# Environmental Impact Statement

## Accelerator Production of Tritium at the Savannah River Site

**Final  
March 1999**

**TITLE:** Final Environmental Impact Statement: Accelerator Production of Tritium at the Savannah River Site (DOE/EIS-0270)

Figure 4-15. Comparison of Baseline APT Footprint to Modular APT Footprint at the preferred site.

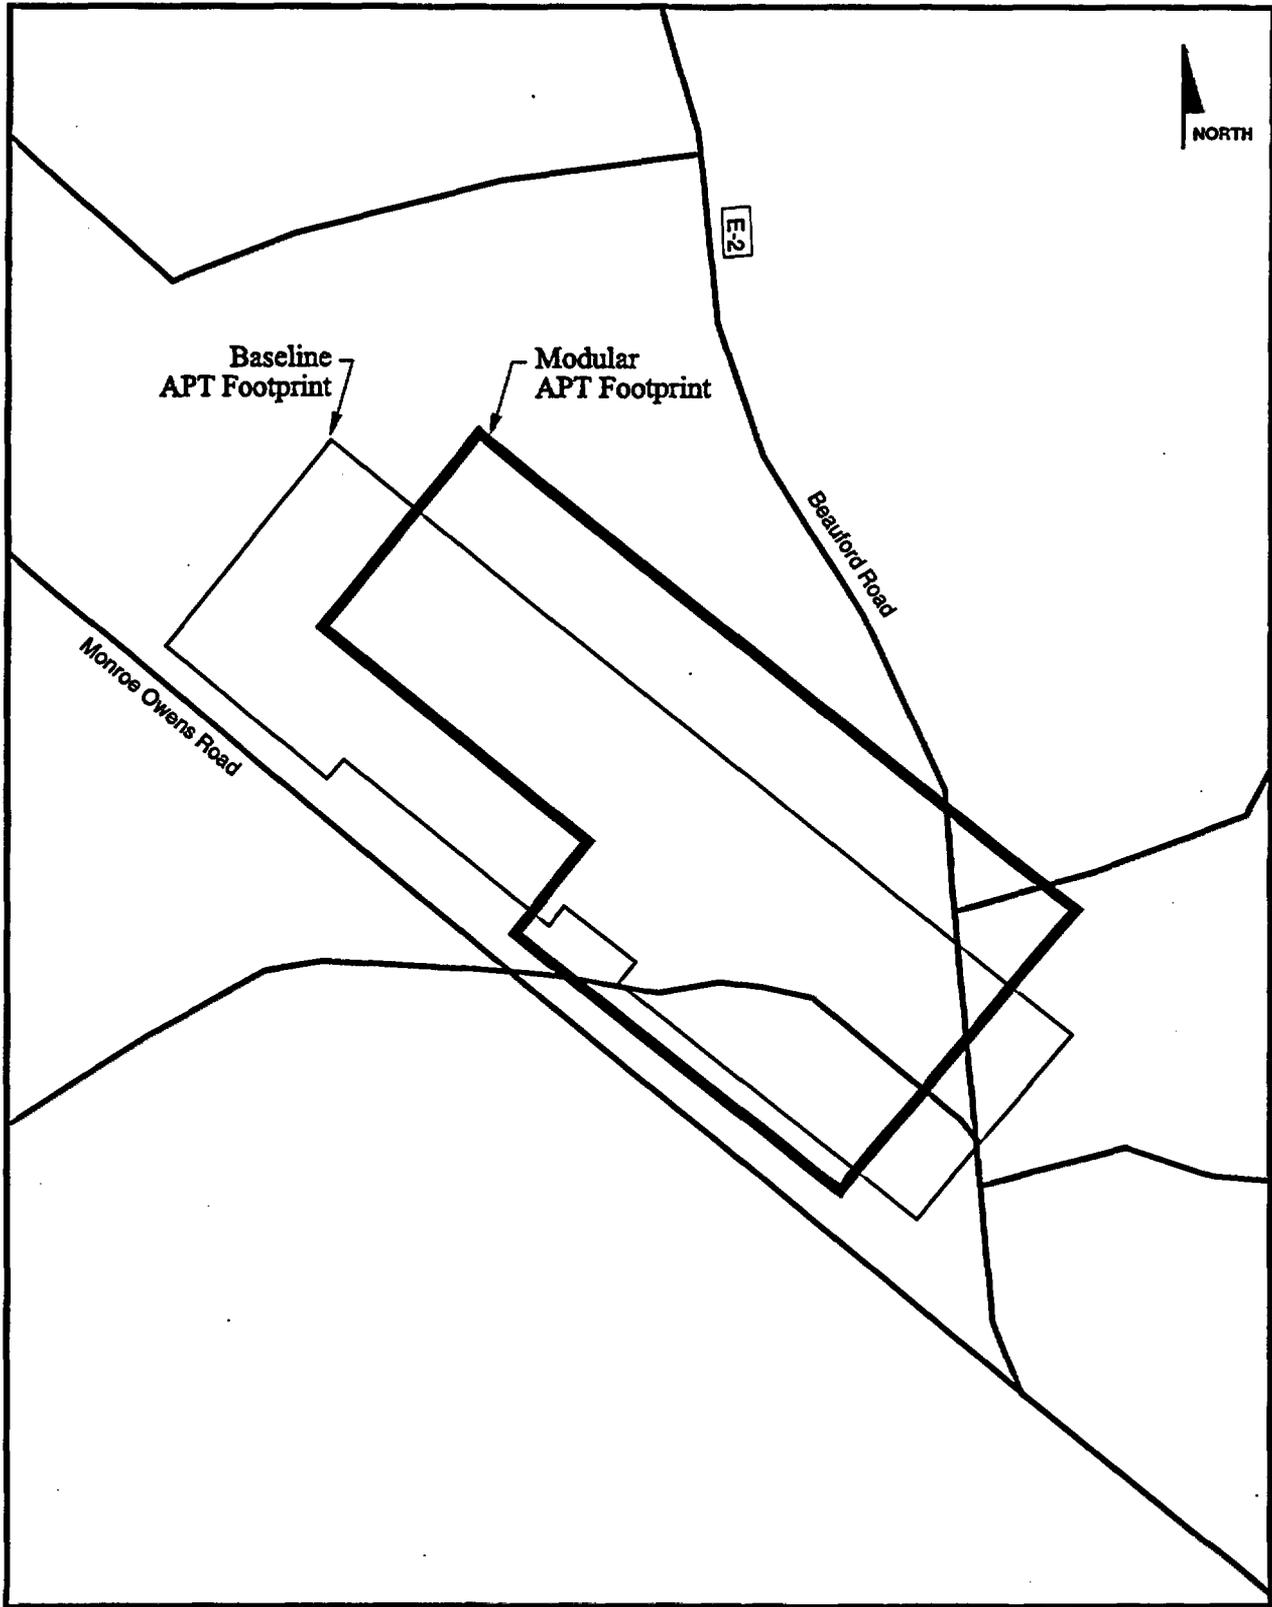
**Differences from baseline APT:** The layout of the buildings for the modular APT is somewhat different from the baseline APT (see Figures 4-15 and 4-16). The modular APT footprint would be slightly wider than the baseline footprint; however, the total area required would remain less than the 250 acres needed for the baseline footprint. This change in footprint shape brings into the APT site both soil and forest areas that were not described in the Draft APT EIS. These areas have the same characteristics as the areas previously described in the Draft EIS. The impacts would be the same as for the baseline APT.
